# A47 Wansford to Sutton Dualling

## **9.21 Applicant's Comments on Deadline 4 Submissions**

A47 Wansford to Sutton  
Development Consent Order 202[x]

**9.21 APPLICANT'S COMMENTS ON DEADLINE 4  
SUBMISSIONS**

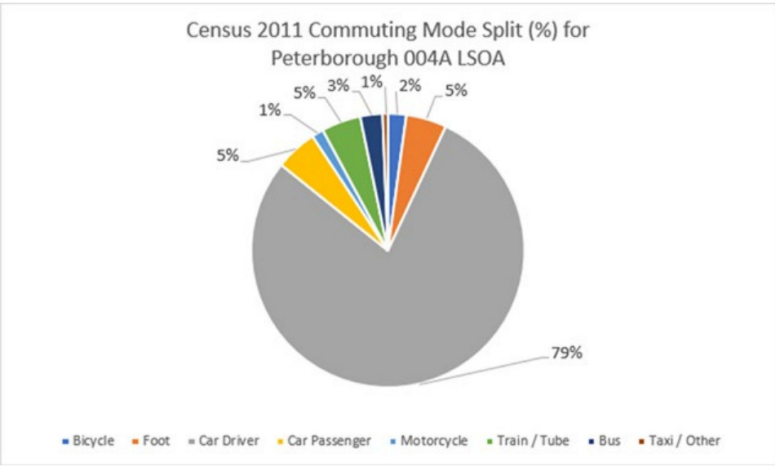
Response	Applicant's Response
1	Please find below our responses to the actions arising from Issue Specific Hearing 2 - Environment, which took place on 15 March 2022, with Natural England in attendance.	No response required.
2	<p>20. Natural England to provide a response to ExQ1.2.6 Construction and operational impacts on ecology</p> <p>a) Do IPs agree with the Applicant's assessment of impacts during both construction and operation as set out in Tables 8-9 and 8-10 of Chapter 8 of the ES [AS 015]?</p> <p>b) If not, could you explain why not and what needs to be amended?</p> <p><i>a) Natural England is satisfied with the Applicant's assessment of impacts during both construction and operation as set out in Tables 8-9 and 8-10 of Chapter 8 of the ES.</i></p>	This comment is noted.
3	<p>21. Natural England to review its records and provide information as to why the Sutton Heath and Bog SSSI was designated.</p> <p><i>Natural England is currently reviewing habitat mapping drawings of Sutton Heath and Bog SSSI from 1985 and 1987, as well as the criteria for selection of the SSSI from 1984. We will provide a full response by D5.</i></p>	This comment is noted.

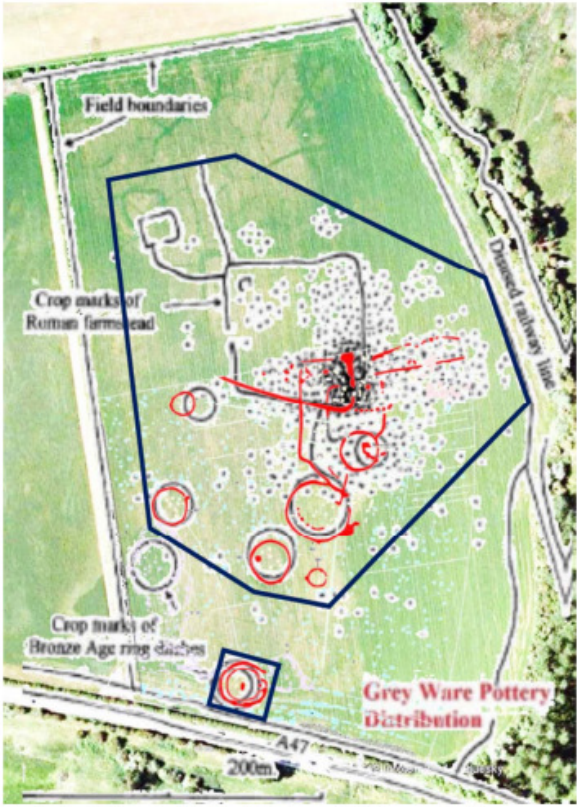
Response	Applicant's Response
REP4-040 3	<p><u>Response by Peterborough City Council to Actions arising from: Issue Specific Hearing 3 – Traffic &amp; Transport and Socio-Economics</u></p> <p><b>Action Point 35: Information held on extent of use of roads by NMUs to north of A47 at present</b></p> <ul style="list-style-type: none"> <li>Do we have any data as to the extent of NMU's for the roads north of the A47?</li> </ul> <p>We do not hold any NMU data for the roads north of the A47 unfortunately. However, the Census 2011 data for the Peterborough 004A LSOA, which covers much of Langley Bush Road, shows the mode split for commuters and has been summarised below.</p>  <p>Census 2011 Commuting Mode Split (%) for Peterborough 004A LSOA</p> <p>79% Car Driver, 5% Car Passenger, 5% Bicycle, 5% Foot, 2% Motorcycle, 1% Train / Tube, 1% Bus, 3% Taxi / Other</p>	No response required.
REP4-040 4	<ul style="list-style-type: none"> <li>Langley Bush Road - Do we have any data on the traffic split for this road and the HGV use?</li> </ul> <p>Please see the below data for Langley bush road (top left)</p>	The Applicant has referred to this data in its response to <b>Action Point 37</b> within Applicant's Further Response to Actions from Hearings ( <b>TR010039/EXAM/9.22</b> ), (see full response included as a response to REP4-023 of this document on page 10).

Response	Applicant's Response																																																
<p>and Walcot Road East (top right) which is another local road similar in nature. The vehicle split is typical of a rural road with agricultural traffic in the west of the authority area and for comparison purposes we have also provided splits based on</p> <p>2009 AADT data from the DfT for High Field Road to the west of Langley Bush Road. We have also provided The National Road Traffic Forecasts for Minor Roads in the East of England Region which show a HGV% figure of 1.3% as shown below</p>																																																	
<div><div><p>Bi-directional Vehicle Split (%) on Langley Bush Road, Helpston</p><table border="1"><thead><tr><th>Vehicle Type</th><th>Percentage (%)</th></tr></thead><tbody><tr><td>Car</td><td>85.9%</td></tr><tr><td>LGV</td><td>10.8%</td></tr><tr><td>PSV</td><td>0.3%</td></tr><tr><td>Motorcycle</td><td>0.7%</td></tr><tr><td>HGV Total</td><td>2.4%</td></tr></tbody></table></div><div><p>Bi-directional Annual Average Daily Traffic Vehicle Split (%) on High Field Road, West of Langley Bush Road</p><table border="1"><thead><tr><th>Vehicle Type</th><th>Percentage (%)</th></tr></thead><tbody><tr><td>Car</td><td>92.0%</td></tr><tr><td>LGV</td><td>5.1%</td></tr><tr><td>PSV</td><td>0.0%</td></tr><tr><td>Motorcycle</td><td>0.0%</td></tr><tr><td>HGV</td><td>2.9%</td></tr></tbody></table></div><div><p>Bi-directional Vehicle Split (%) on Walcot Rd East, Near Ufford</p><table border="1"><thead><tr><th>Vehicle Type</th><th>Percentage (%)</th></tr></thead><tbody><tr><td>Car</td><td>87.0%</td></tr><tr><td>LGV</td><td>9.9%</td></tr><tr><td>PSV</td><td>0.1%</td></tr><tr><td>Motorcycle</td><td>1.1%</td></tr><tr><td>HGV Total</td><td>1.9%</td></tr></tbody></table></div><div><p>National Road Traffic Forecasts for East of England - Vehicle Splits (%) for Minor Roads</p><table border="1"><thead><tr><th>Vehicle Type</th><th>Percentage (%)</th></tr></thead><tbody><tr><td>Car</td><td>81.9%</td></tr><tr><td>LGV</td><td>15.9%</td></tr><tr><td>PSV</td><td>0.9%</td></tr><tr><td>HGV</td><td>1.3%</td></tr><tr><td>Motorcycle</td><td>0.9%</td></tr></tbody></table></div></div>	Vehicle Type	Percentage (%)	Car	85.9%	LGV	10.8%	PSV	0.3%	Motorcycle	0.7%	HGV Total	2.4%	Vehicle Type	Percentage (%)	Car	92.0%	LGV	5.1%	PSV	0.0%	Motorcycle	0.0%	HGV	2.9%	Vehicle Type	Percentage (%)	Car	87.0%	LGV	9.9%	PSV	0.1%	Motorcycle	1.1%	HGV Total	1.9%	Vehicle Type	Percentage (%)	Car	81.9%	LGV	15.9%	PSV	0.9%	HGV	1.3%	Motorcycle	0.9%
